Hills Showground Station Precinct

Response to RFI by Department of
Planning, Industry and Environment

November 2020

Building Heights Plan in Drawings for Approval

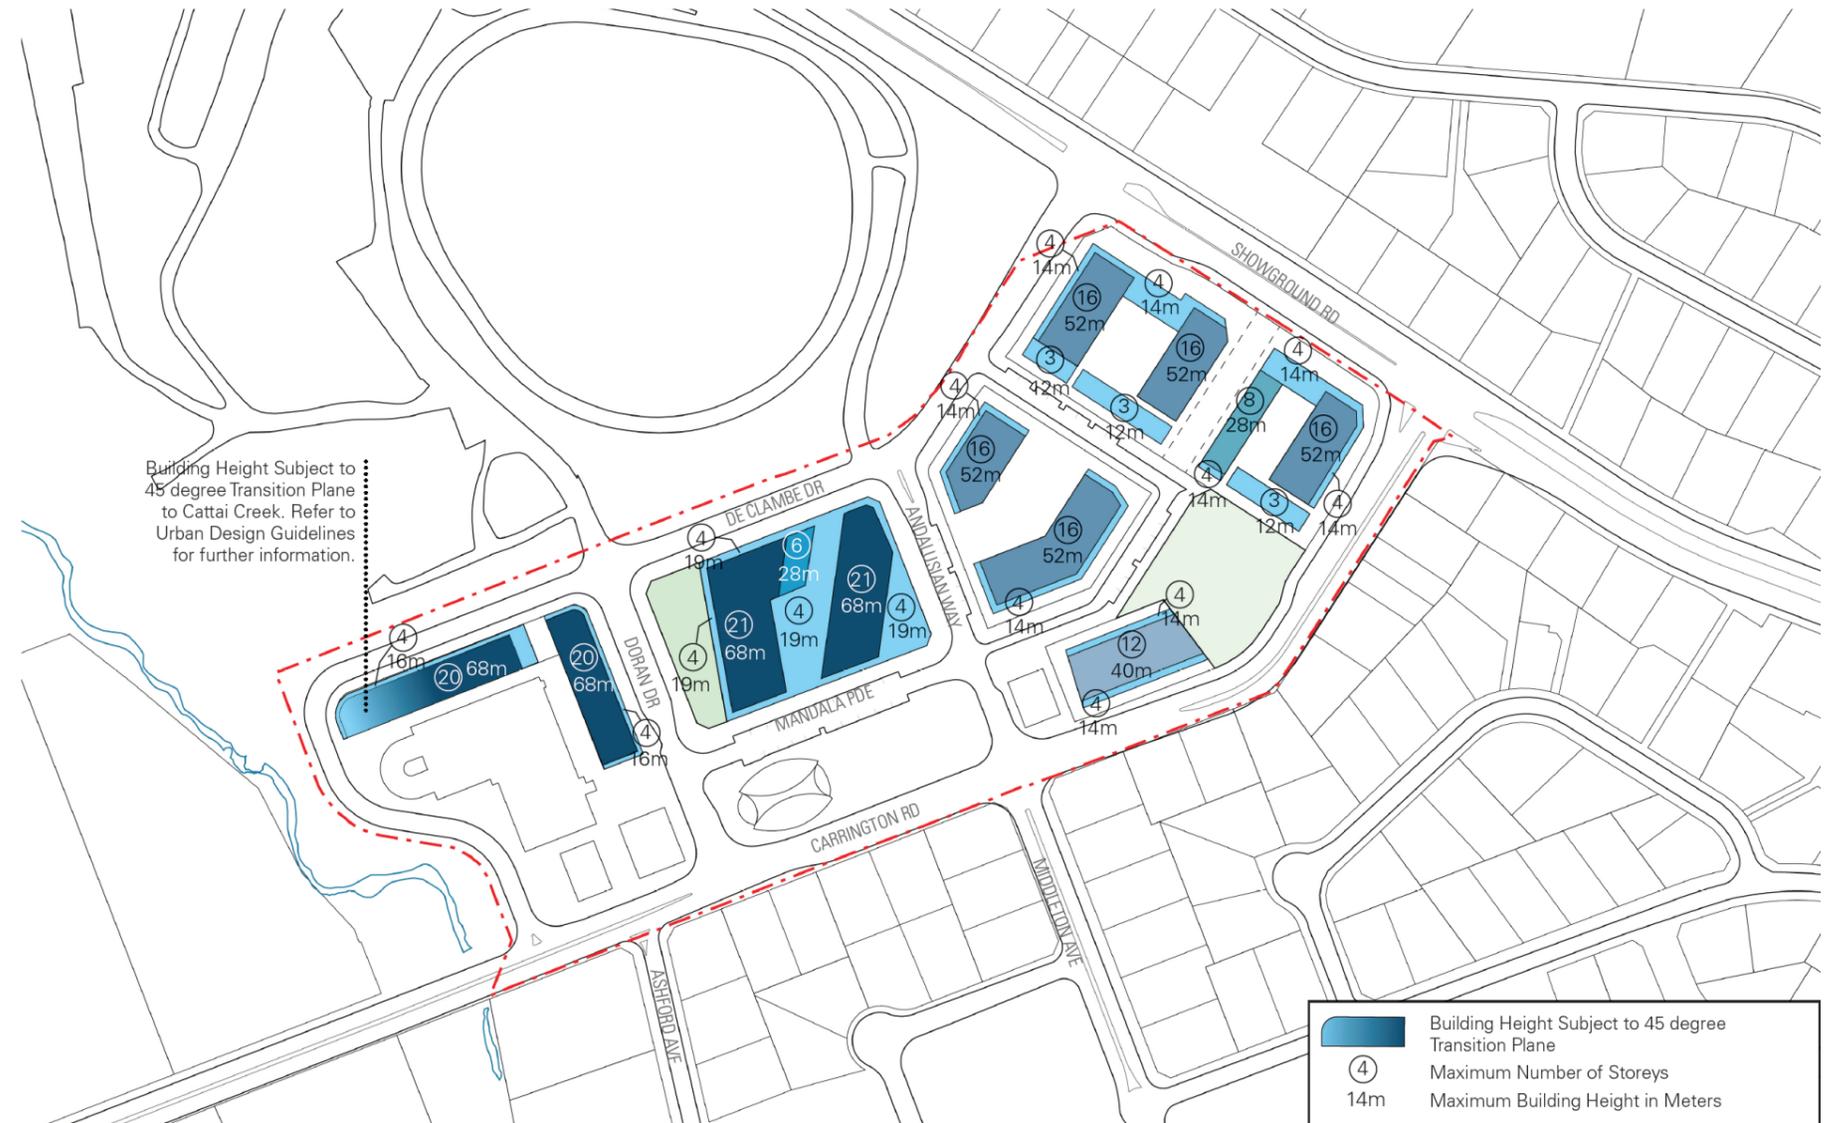
“Amend the Building Heights Plan to include both height in storeys and metres to be consistent with the proposed Design Guidelines.”

The drawings for approval - Building Heights Plan - has been amended to include heights in storeys and metres
